LEDIAN M. WILLIAMS SUBDIVISION

APPLICATION NUMBER 13 DATE November 21, 2013

REQUEST Subdivision

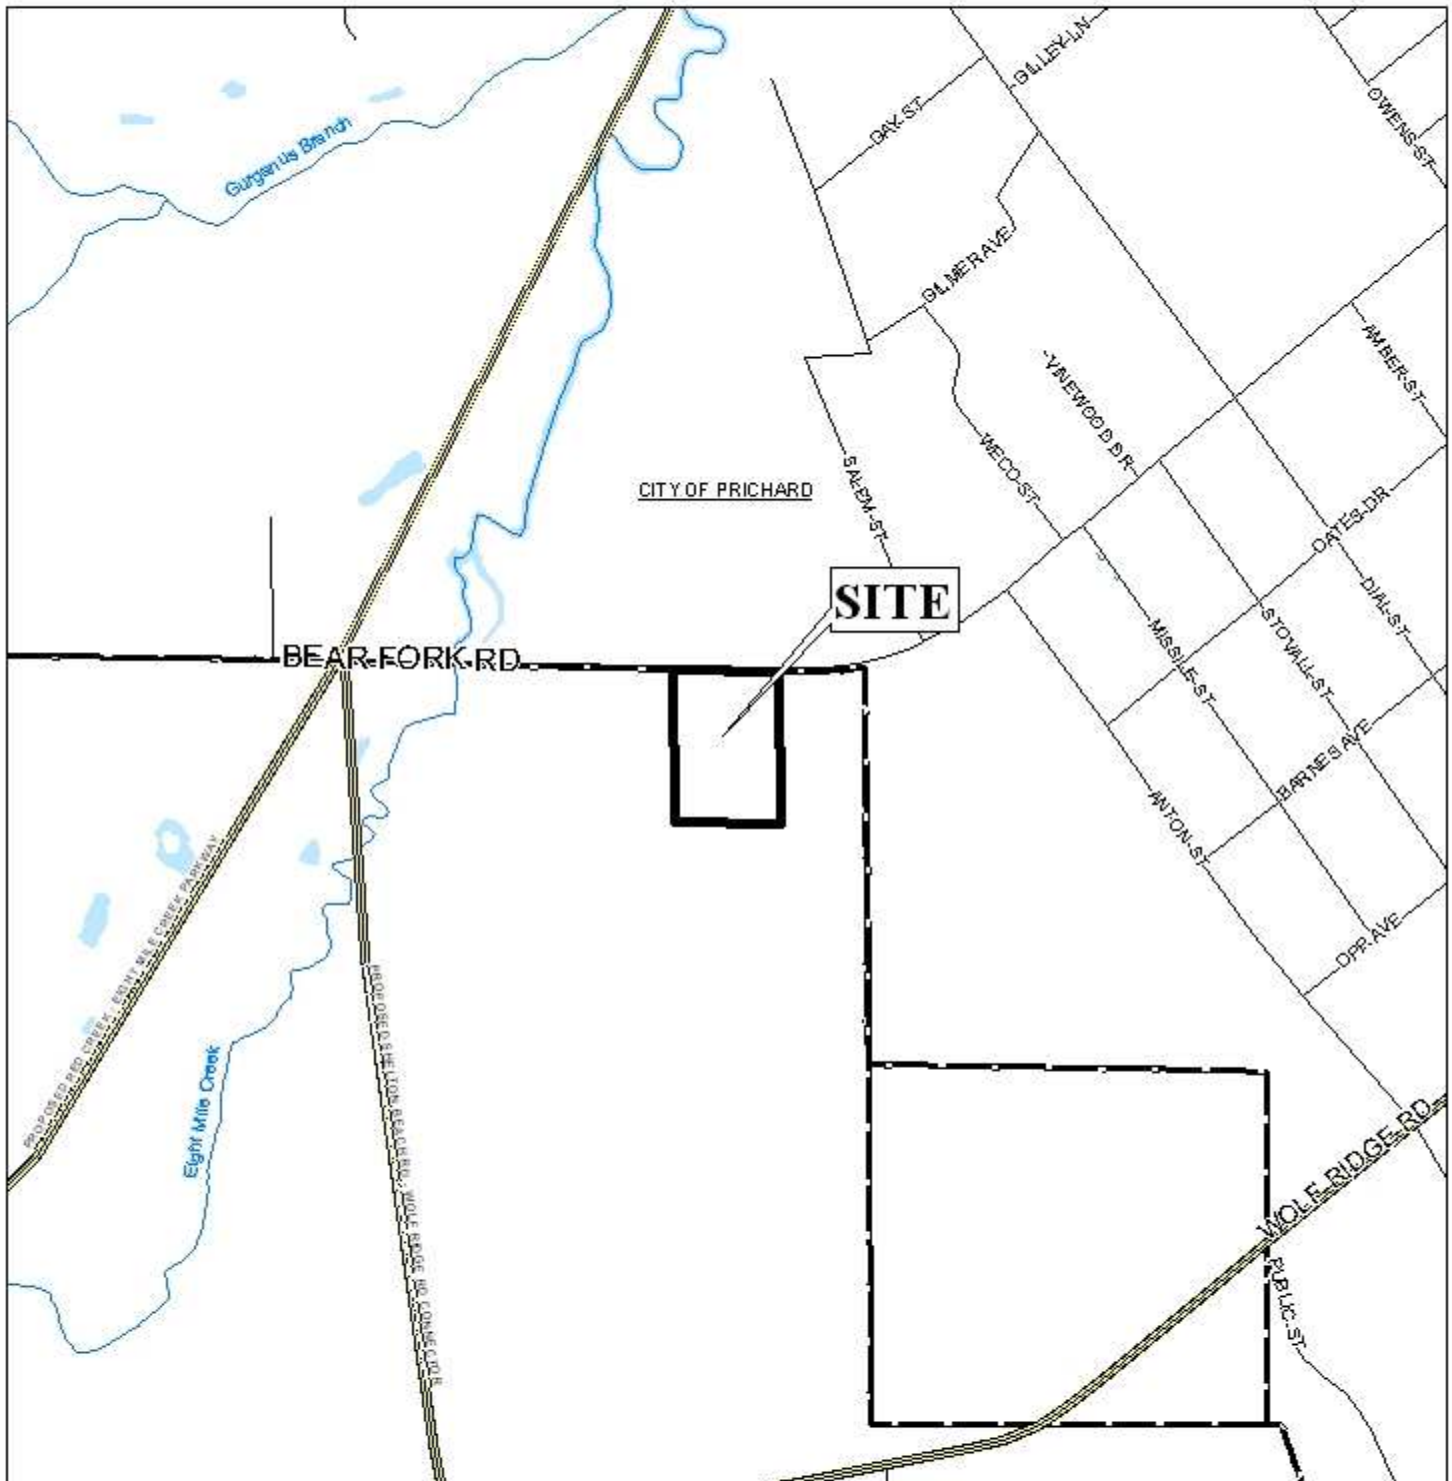
- a. Add a note to the Plat stating that storm water detention will be required for any future addition(s) and/or land disturbing activity in accordance with the Storm Water Management and Flood Control Ordinance (Mobile City Code, Chapter 17, Ordinance #65-007 & #65-045).

- b. Add a note to the Plat stating that the approval of all applicable federal, state, and local agencies (including all stormwater runoff, wetland and floodplain requirements) would be required prior to the issuance of a permit for any land disturbance activity.

- c. Add a signature block for the Traffic Engineer.
- d. There are two (2) signature blocks for the County Engineer. One is labeled Mobile County Engineer.

- e. Provide the Surveyor's, Owner's (notarized), Planning Commission, and Traffic Engineering signatures.
- f. Provide larger street name labels in the vicinity map. Include Dekle Dr. and I-165.

- g. Some bearing/distance callouts show actual and record information; but the curve data does not indicate that there was a difference between the record and actual. Please clarify.

- h. Show and label the MFFE (Minimum Finished Floor Elevation) on LOT 2.
- i. Provide and label the POC, the POB, and the tie line in between the two points.

- j. Provide a Drainage Easement for the existing drainage ditch. Size and location to be approved by the City Engineer.

The site fronts Bear Fork Road, a minor street which does not have curb and gutter. In compliance with Section V.B.14. of the Subdivision Regulations, a 60' right-of-way is required and is illustrated on the preliminary plat; however, it should be pointed out that the current right-of-way appears to be 40', which would provide only 20' as measured from centerline. As a result, the applicant has proposed a dedication of 10' which should provide 30' from the centerline of Bear Fork Road; but, if necessary, dedication will still be required in order to provide 30' as measured from centerline if dedication is not sufficient.

As a means of access management, both proposed Lot 1 and Lot 2 should be limited to one curb-cut each along Bear Fork Road. The size, design and location of both curb-cuts are to be approved by Traffic Engineering and conform to AASHTO standards.

GIS data indicates the western portion of the proposed Lot 2 is located within AE and X-Shaded flood zones due to the proximity to Eight Mile Creek. The presence of a flood zone would indicate that the area may be environmentally sensitive; therefore, if approved, the approval of all applicable federal, state and local environmental agencies would be required prior to the issuance of any permits or land disturbance activities.

- 1) Dedication, if necessary, to provide 30' from the centerline of Bear Fork Road;
- 2) Retention of the 25-foot minimum setback line and lot size information on the Final Plat and adjusted for dedication;

- 3) Placement of a note on the Final Plat limiting each lot one curb-cut to Bear Fork Road with the size, design and location to be approved by Traffic Engineering and conform to AASHTO standards;

- 4) Placement of a note on the Final Plat stating: *(The approval of all applicable federal, state and local environmental agencies is required for wetland and flood zone issues prior to the issuance of any permits or land disturbance activities.);*
